PLAN COMMISSION

OFFICIAL NOTICE & AGENDA

A meeting of the Town of Rib Mountain Plan Commission will be held on **Wednesday, June 14th, 2017; 6:30 P.M. at 3700 North Mountain Road, Town of Rib Mountain Municipal Center**. The Town Board may attend for purposes of gathering information. Subject matter for consideration and possible action follows:

CONCEPTUAL DEVELOPMENT PLAN

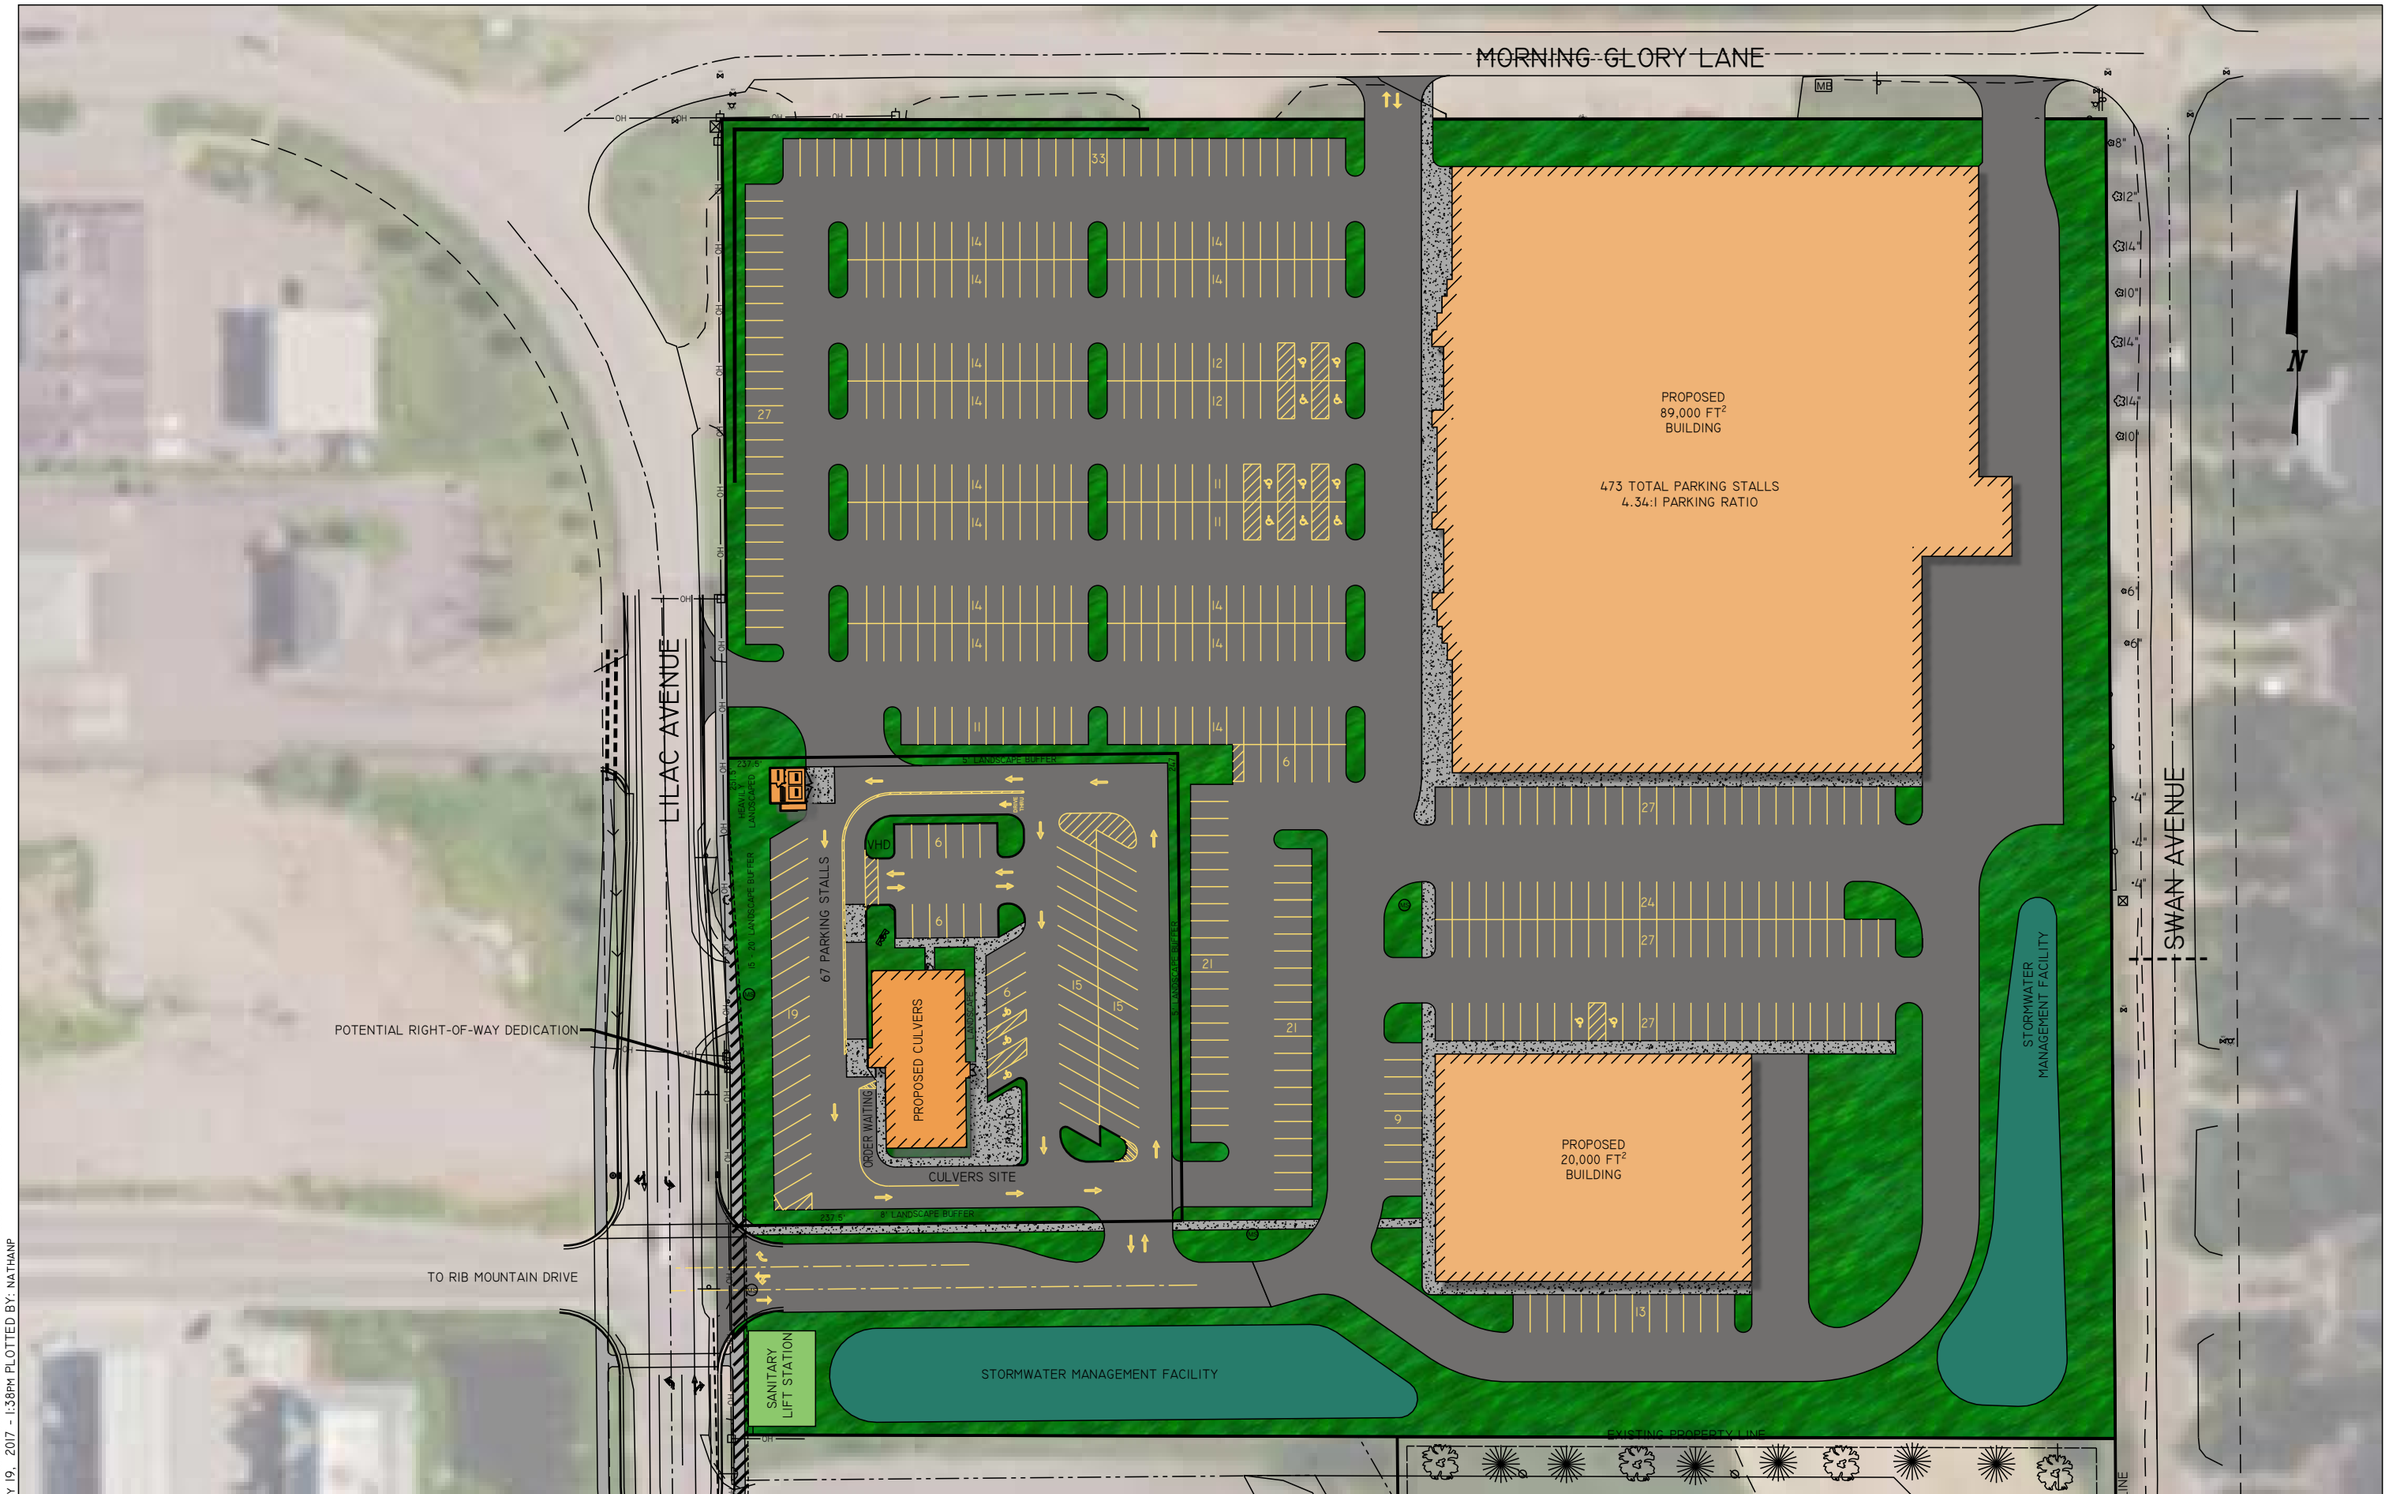
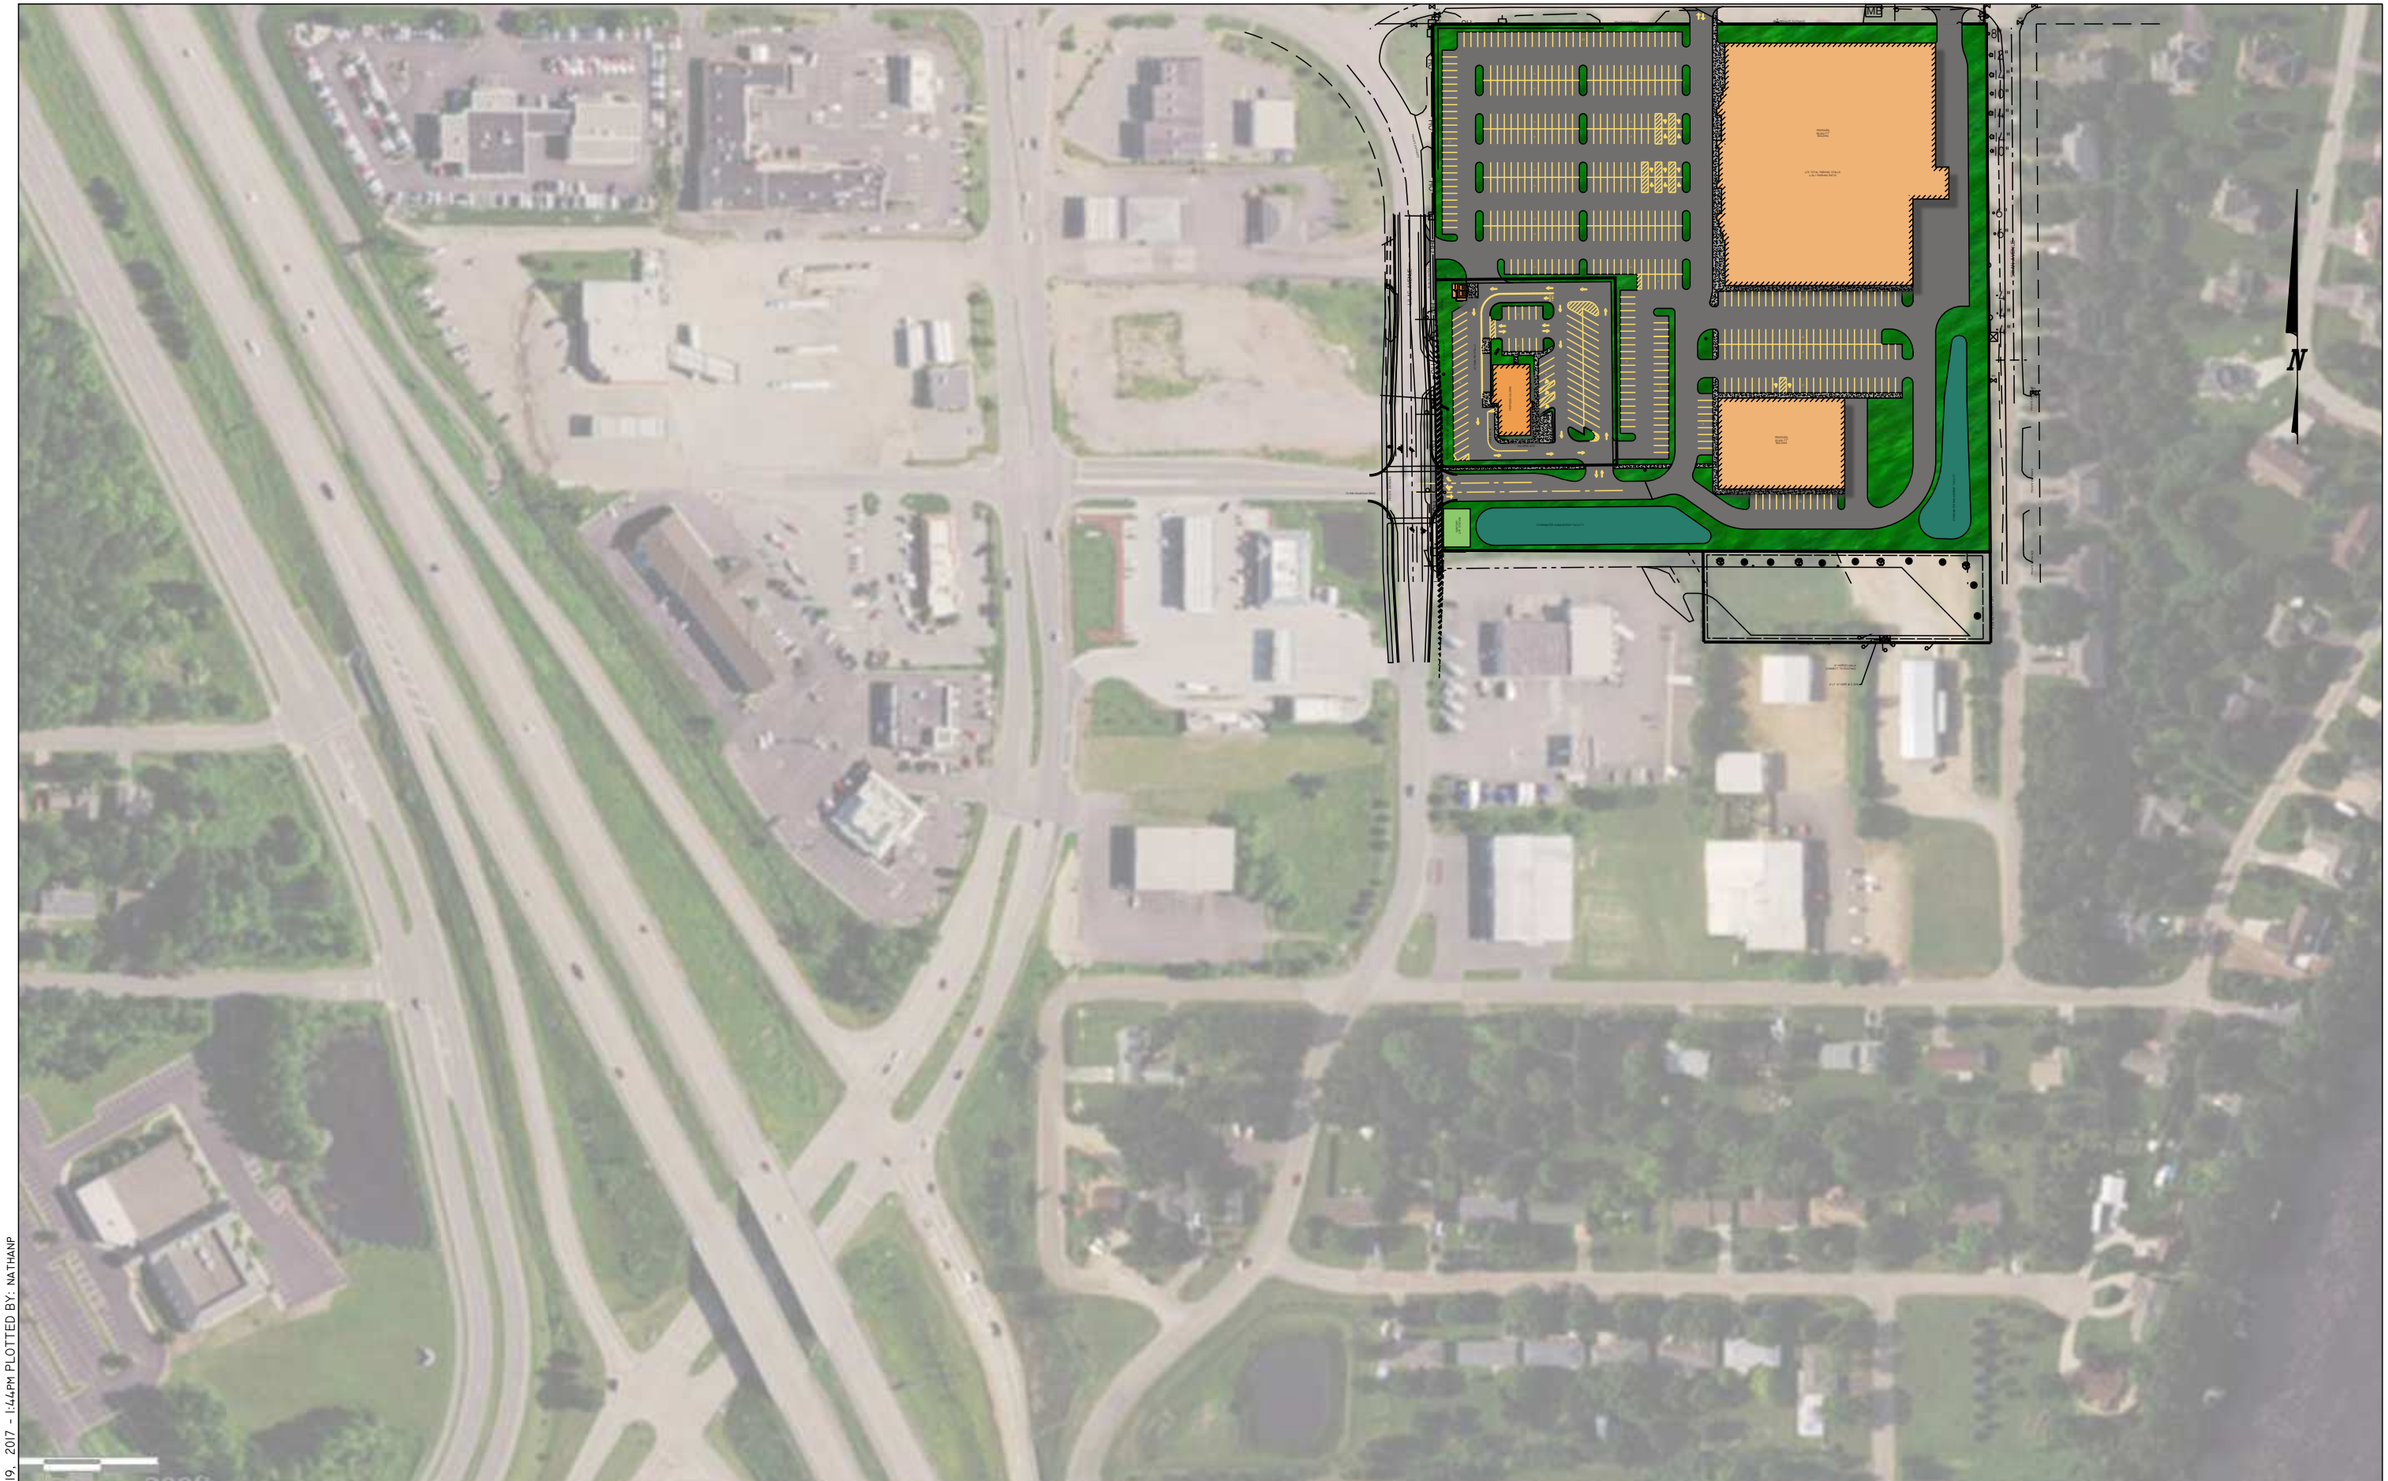
NARRATIVE:
The applicant seeks Plan Commission input on a proposal to redevelop property east of Kwik Trip bounded by Lilac Avenue to the west, north of Ryder Truck and south of Morning Glory Lane (see attached map). The proposal calls for a mix of restaurant and retail uses, specifically including a Culver's restaurant with a drive-thru. At this stage of the process, tenants are not identified for either retail structure depicted on the attached site plan. Initial discussions with the development team indicate the two retail structures will likely be developed in phases.

Per the Town's Zoning Ordinance, drive-thru restaurants are identified as both 'Indoor Commercial Entertainment' and 'In-Vehicle Sales and Service' uses. Each of these uses are typically handled as conditional uses in the Town's commercial zoning districts. Below are the typical regulations associated with each use.

Site Plan

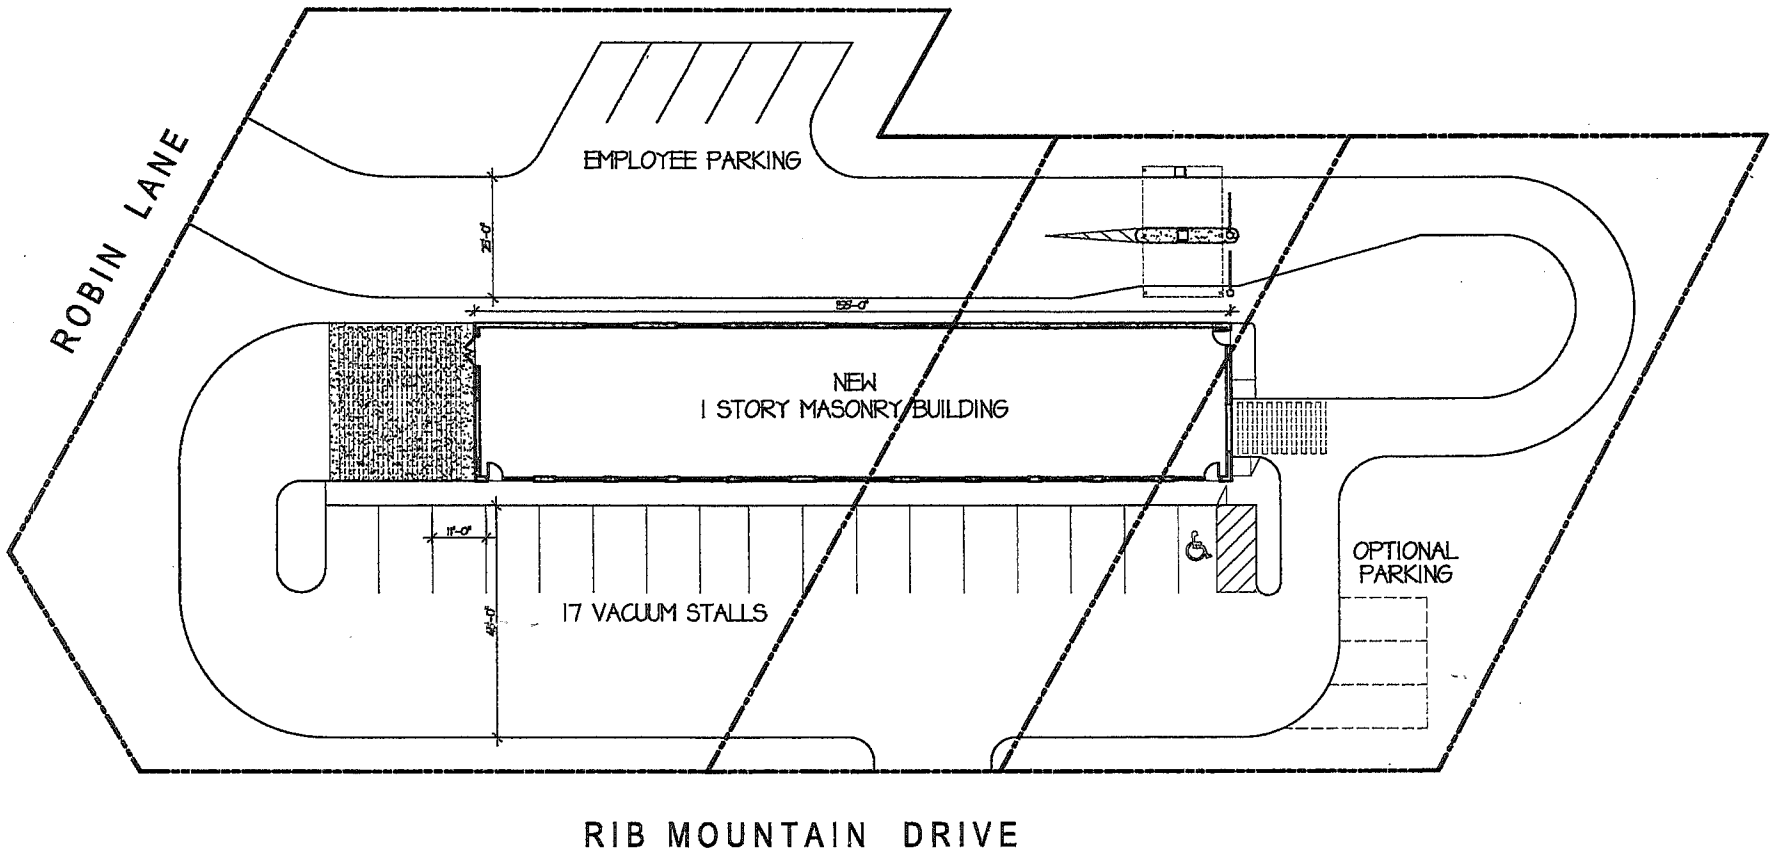
NARRATIVE:
The applicant seeks Plan Commission input on a proposal to develop a standalone carwash facility at the existing Michael's Supper Club location. The Town's Zoning Ordinance identifies all carwash facilities as 'In-Vehicle Sales or Service' and treat them as conditional uses in the Suburban Commercial zoning district. Below is a sample standalone carwash facility obtained from Arch America website (company identified on draft site plan).
